ITEM E5 – FORT RAYMOND SUBDIVISION REPLAT NUMBER 5

KPB File No.	2022-029	
Plat Committee Meeting:	April 11, 2022	
Applicant / Owner:	City of Seward, Alaska	
Surveyor:	Stacy Wessel / AK Lands Land Surveying	
General Location:	Sea Lion Avenue, City of Seward	
Parent Parcel No.:	145-026-23	
Legal Description:	6A-2 Fort Raymond Subdivision Replat Number 3, Plat SW 2012-12	
Assessing Use:	Institutional	
Zoning:	Institutional	
Water / Wastewater	Municipal

STAFF REPORT

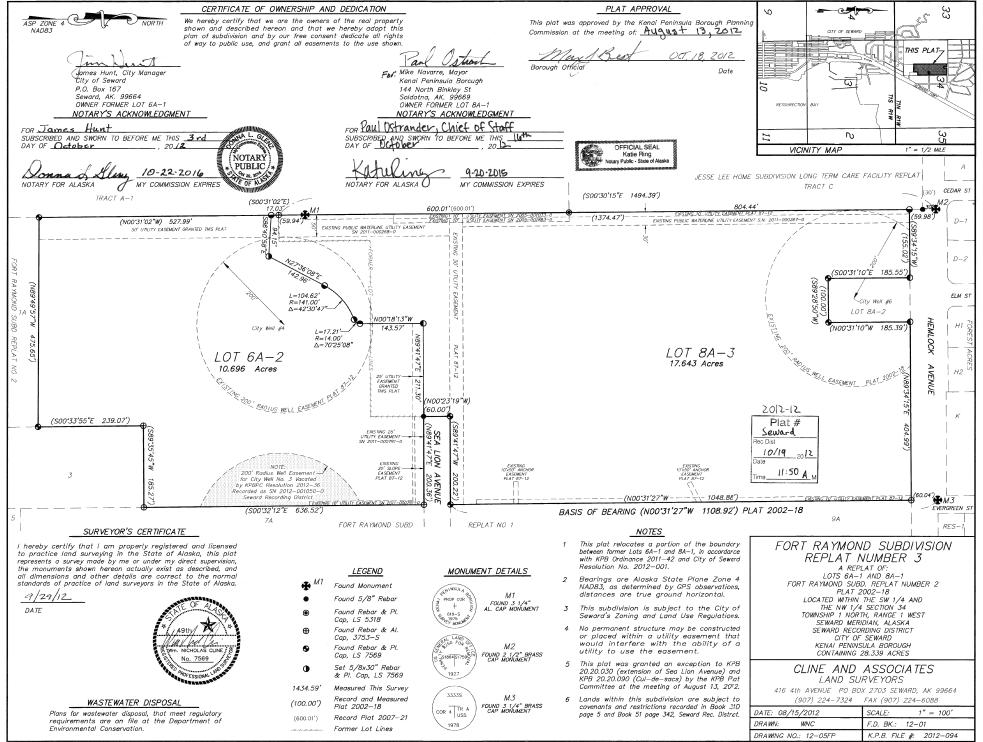
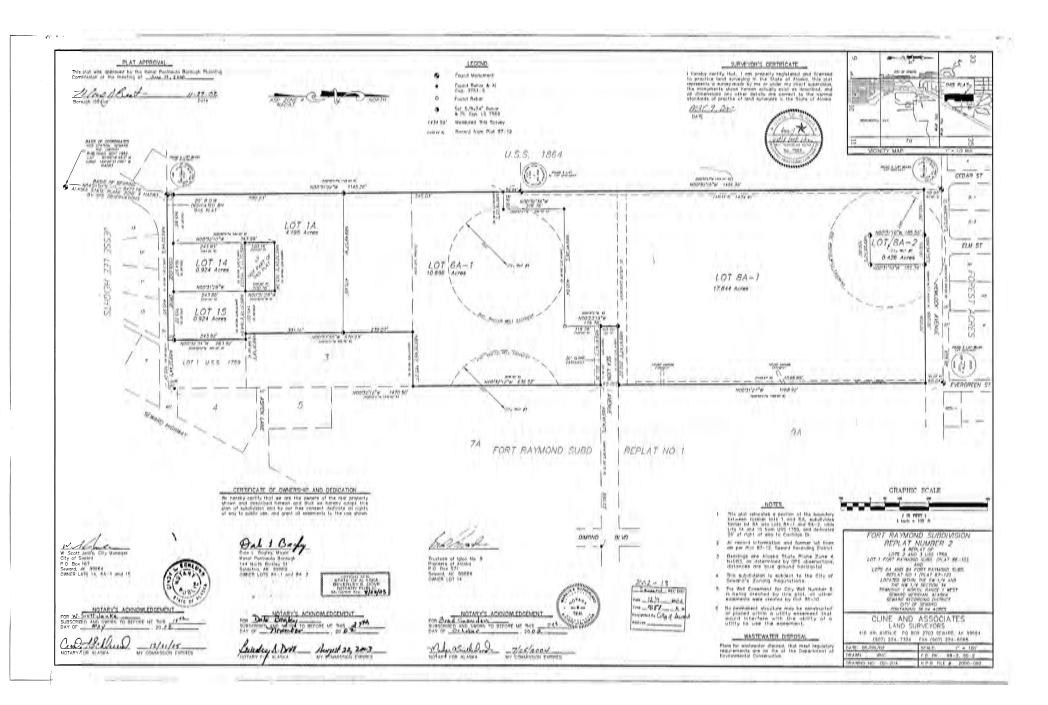
comments: I Still have concerns of the new animal shelter property Line moving further south into to "Public Water Well Protection Area". The planned project Limits were further north, see attached 9/10/22 Date The other well also needs the protection area added to this new plat. * see attached 2 drawings
